Comment Letter O3: Advocates for the Environment, 9 pages

Re: Comments on Draft Environmental Impact Report for Harvest Landing Retail Center & Business Park Project, SCH No. 2024080337

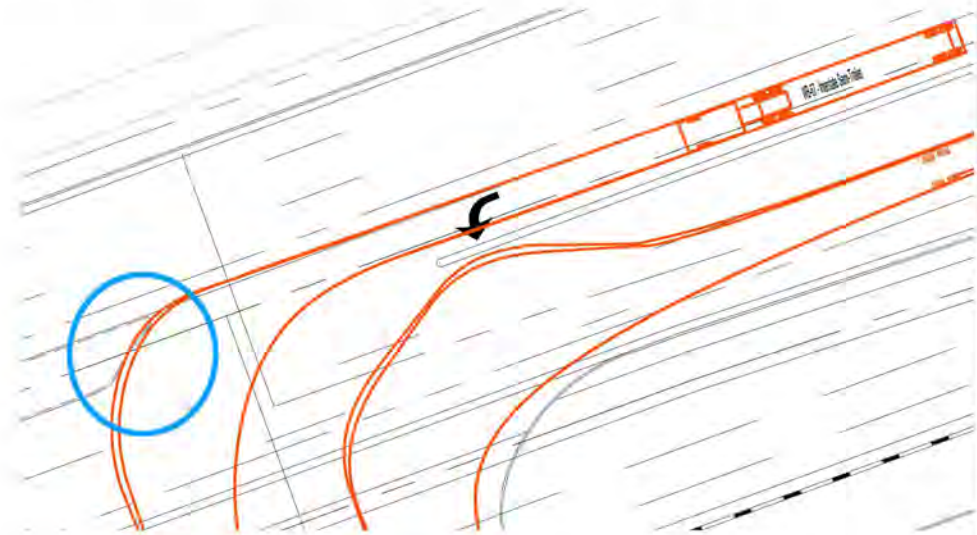
Further, the EIR has underreported the quantity VMT generated by the proposed project operations. The operational nature of industrial/warehouse uses involves high rates of truck/trailer/delivery van VMT due to traveling from large import hubs to regional distribution centers to smaller industrial parks and then to their final delivery destinations. Once employees arrive at work at the proposed project, they will conduct their jobs by driving delivery vans across the region as part of the daily operations as parcel hubs/high-cube fulfillment warehouses, which will drastically increase project-generated VMT. The project’s truck/trailer and delivery van activity is unable to utilize public transit or active transportation and it is misleading to the public and decision makers to exclude this activity from VMT analysis. The project’s total operational VMT generated is further inconsistent with the significance threshold and legislative intent of SB 743 to reduce greenhouse gas emissions by reducing VMT. A revised EIR must be prepared to reflect a quantified VMT analysis that includes all truck/trailer and delivery van activity.

Response O4.21: The commenter incorrectly assumes that the VMT analysis does not consider truck/trailer/delivery van activity. The VMT analysis conducted for the Project utilized an origin-destination (OD) VMT methodology, which captures all trips associated with the Project — not just employee commute trips. This includes VMT from employees, vendors, trucks, delivery vans, and other operational vehicle activity generated by the Project. The OD VMT approach is consistent with the *City of Perris Transportation Impact Analysis Guidelines for CEQA*, adopted by the City Council in May 2020.

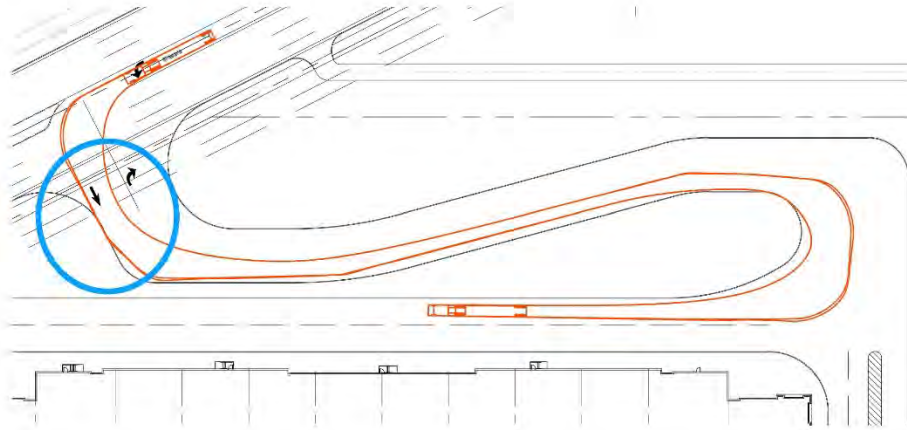
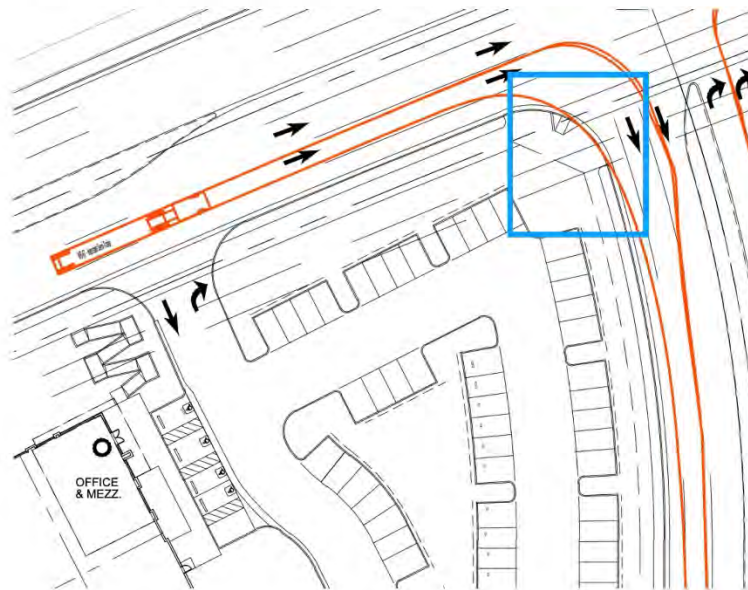
The same is true for the truck entering the site via Frontage Road at Building 6, which will overlap on the internal curb, indicating there is not suitable available space to accommodate truck maneuvering. This exhibit also does not depict two trucks simultaneously entering and exiting site and there does not appear to be enough maneuvering space for two trucks given that there is not enough area for a single truck without overlapping on the internal curb. The geometric design of the circulation system and project site will substantially increase hazards and a significant and unavoidable impact exists, which must be disclosed in a revised EIR.

Comment O4.23: This comment states that the Draft EIR does not adequately analyze the Project's potential impacts regarding hazards due to a geometric design feature. The comment explains that there are areas of overlap between truck movements for the truck entering the site via Frontage Road at Building 6.

Response O4.22: This comment does not provide any substantial evidence that the Project would result in a significant environmental impact. The Project would include five truck driveways along Frontage Road and installation of a truck-only Private Drive A for the industrial portion of the Phase 1 development. The commercial component of the Phase 1 development would require one truck driveway on Orange Avenue, one truck driveway on Harvest Landing Way, and one truck driveway on Barrett Avenue. Lastly, while potential development plans and internal circulation within the Phase 2 area is unknown at this time, the City of Perris will be conditioning future development of the area to solely provide truck driveways for Phase 2 developments on Orange Avenue and Frontage Road in order to avoid the sensitive receptors located along Indian Avenue (with Val Verde Elementary school operational along Indian Avenue) and Barrett Avenue.

Response O4.23: Please refer to Response O4.22.

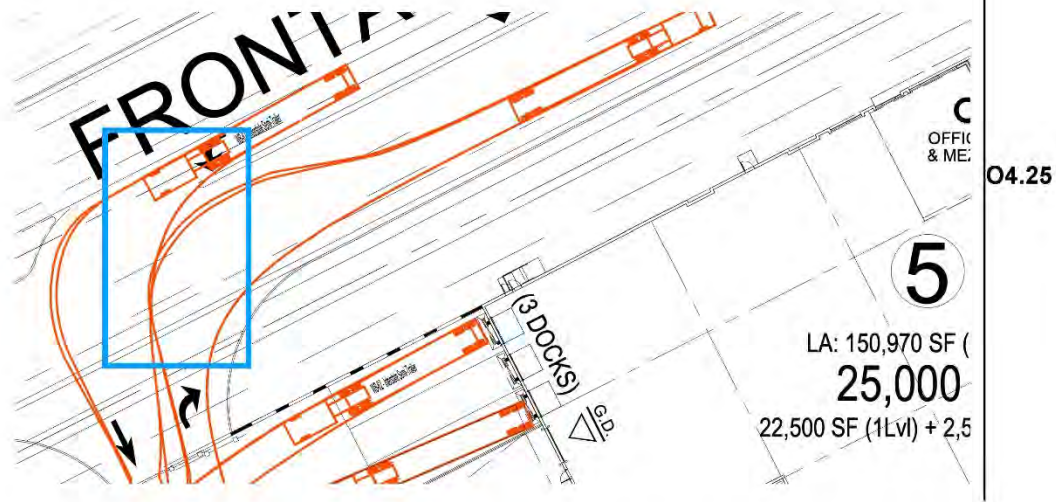
A similar issue exists for the truck entering the site via Frontage Road at Private Drive A between Buildings 2 and 3. This truck will also overlap on the curb, indicating there is not suitable available space to accommodate truck maneuvering. The geometric design of the circulation system and project site will substantially increase hazards and a significant and unavoidable impact exists, which must be disclosed in a revised EIR.

Comment O4.24: This comment states that the Draft EIR does not adequately analyze the Projects potential impacts regarding hazards due to a geometric design feature. The comment explains that there are areas of overlap between truck movements for the truck entering the site via Frontage Road at Private Drive A between Buildings 2 and 3.

Response O4.24: Please refer to Response O4.22.

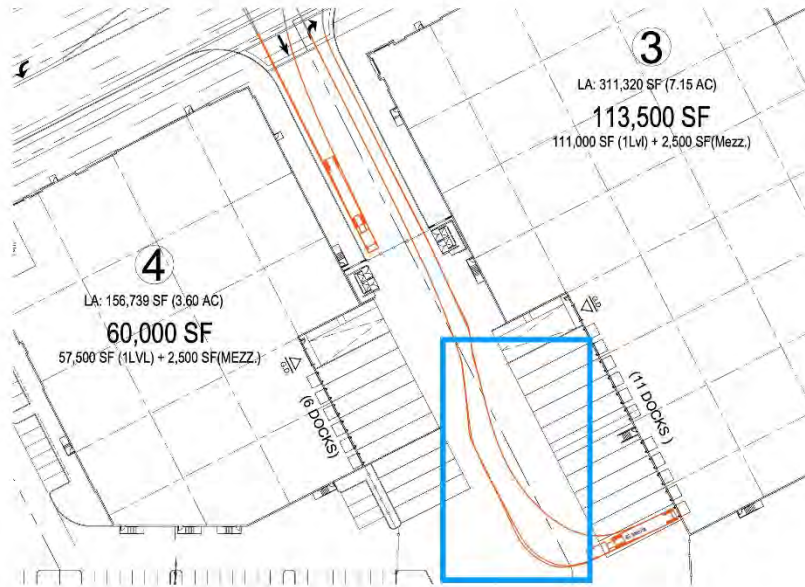
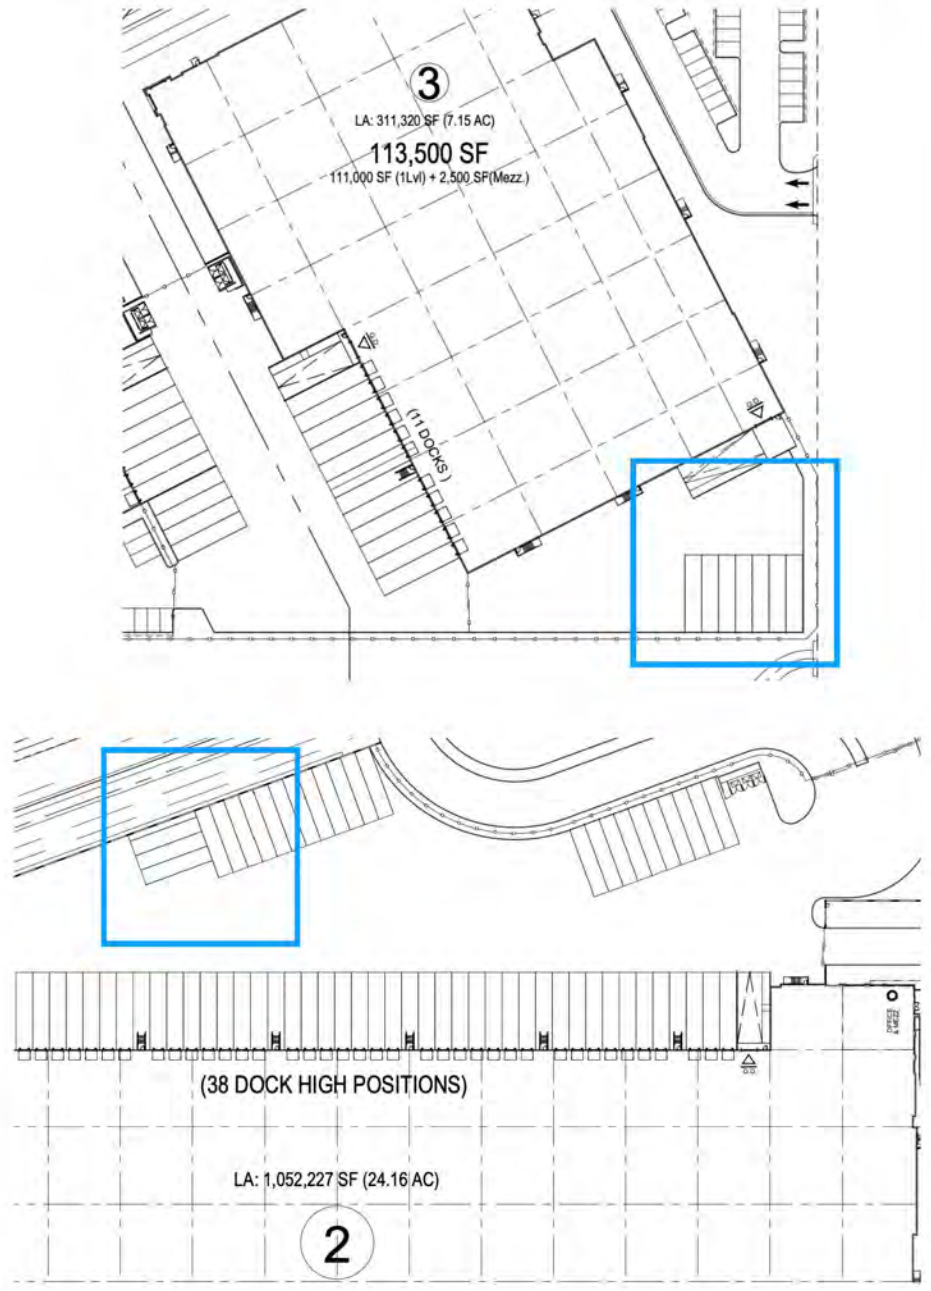
Additionally, trucks accessing the internal truck/trailer loading dock court between Buildings 3 and 4 do not have adequate internal maneuvering space. As shown below, a single truck backing into a loading dock space requires the entire loading dock area to maneuver into the space. There is no other maneuvering area available, meaning that other trucks must queue and wait for the area to clear in order to proceed. Increased queuing results in increased idling (and associated emissions) will require increased internal queuing area in order to avoid queuing on Frontage Road. The geometric design of the circulation system and project site will substantially increase hazards and a significant and unavoidable impact exists, which must be disclosed in a revised EIR.

There are no exhibits adequately depicting the onsite turning radius available for trucks maneuvering throughout the parking areas of the site. For example, the truck/trailer parking spaces are located within the truck/trailer loading dock court and some are designed in unconventional configurations that restrict internal maneuvering area, as shown below. These parking stalls that may be in use at any time and further restrict truck/trailer movement, including increasing truck idling as tandem parked trucks require additional time to maneuver, which will also result in increased queuing duration and associated queuing area for trucks/trailer. A revised EIR must be prepared to include a finding of significance due to these significant and unavoidable impacts that have not been analyzed.

Comment O4.26: This comment states that the Draft EIR does not adequately analyze the Project's potential impacts regarding hazards due to a geometric design feature. The comment explains that there are areas of overlap between truck movements for the trucks accessing the internal truck/trailer loading dock court between Buildings 3 and 4. Additionally, the comment states that there are no exhibits adequately depicting the onsite turning radius available for trucks maneuvering throughout the parking areas of the site as well as exhibits depicting emergency vehicle access and maneuvering. The comment concludes in stating that the Draft EIR defers analysis by stating that the Riverside County Fire Department would review plans without listing any requirements.

Response O4.26: As shown in Appendix R of the Draft EIR (Table 4.1b: Project Trip Generation), buildings 3, 4 and 5 would have a truck trip generation of 6 truck trips (3 total trucks) during the AM peak hour and 5 truck trips (3 total trucks) during the PM peak hour. These trips are for all three buildings, resulting in a maximum of 1 to 2 trucks per hour entering or leaving each building. Because of the very low volume of trucks entering and departing, delays would be minimal. It is likely that trucks would not be entering or leaving at the same time. Therefore, additional emissions or queuing due to conflicts between trucks would be negligible and not measurable. Therefore, the results of the analysis would remain unchanged.

As detailed in Section 3.0, *Project Description*, the proposed Project would include two emergency access only driveways, one along Orange Avenue accessing MBU Building 2 and one along Barrett Road accessing MBU Building 7. As detailed in Response to Comments O4.22 through O4.25, the proposed onsite conceptual circulation design provides emergency vehicle accessibility and turning ability throughout the site and does not identify potential significant environmental impacts. Should the Project be approved, design level civil engineering plans would be prepared and reviewed by the City's engineering staff prior to issuance of construction related permitting to ensure that all applicable emergency access standards are met, which include both California Fire Code and California Building Code requirements, as included in the Perris Municipal Code (Sections 16.08.058 and 16.08.050). This is not a deferral of analysis, but the City's standard development review and permitting process to ensure that all applicable design requirements are met, including emergency access.

Figure 1. Existing, approved, and under review warehouses along the 215/60 corridor centered on the project. Screenshot from Warehouse CITY v1.23.

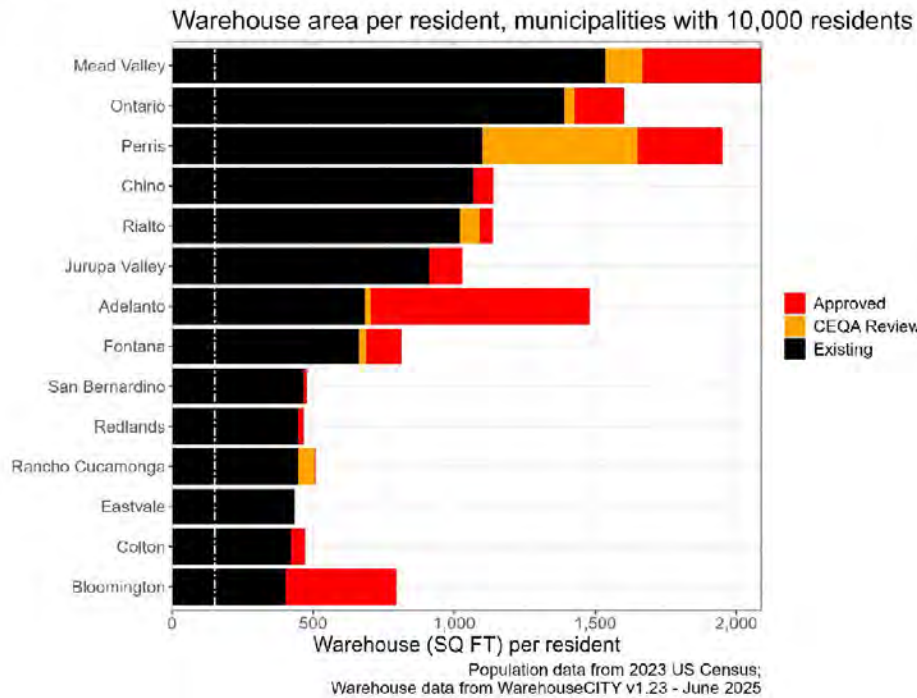
When the full list of local and regionally important projects is considered, the cumulative impacts will be seen. **Figure 1** shows a reasonable cumulative impacts map for warehouses. **Figure 2** shows the cumulative area per resident by municipality (> 10,000 residents). Perris is currently third and on its way to overtake Ontario. And the most burdened community is next door in Mead Valley. Note that March JPA is not included but has another 20M square feet of warehouses for a minimal population.

Comment O5.2: This comment states that the cumulative list excludes over 100 million square feet of warehouse development. The comment states that the cumulative analysis should account for local and regional warehouse development including the World Logistics Center, Stoneridge Commerce Center, San Jacinto Commerce Center, New Perris Commerce Center, South Perris Industrial, Ellis Logistics Center, Mapes Commerce Center; the 1,100 acres of foundation amendment projects in Mead Valley; all projects in Menifee along Ethanac Road, including Northern Gateway Logistics, Murrieta Road Warehouse, Ethanac Logistics Center, Menifee Commerce Center, and the Menifee Valley Specific Plan. The comment states that a full list of projects that need to be included are described in detail later.

Response O5.2: The Draft EIR prepared for the proposed Project accurately analyzes potential cumulative impacts from the Project in conjunction with other industrial developments in the Project vicinity throughout the Draft EIR and specifically under the cumulative impacts section in each Section 5 subsection. The Draft EIR cumulative analyses uses a combination of the list method and the projection method, as appropriate based on different topic areas, as detailed in each cumulative analysis discussion in the Draft EIR. Table 5-1 of the Draft EIR lists cumulative projects utilized in the cumulative analysis of the Project in the topical areas that use the list approach. The list of cumulative projects was developed using a list of past, present and future projects within the Project vicinity that could have a potentially cumulative impact on specific EIR topical areas. The additional projects that the commenter provided were not included in the cumulative project list for the following reasons:
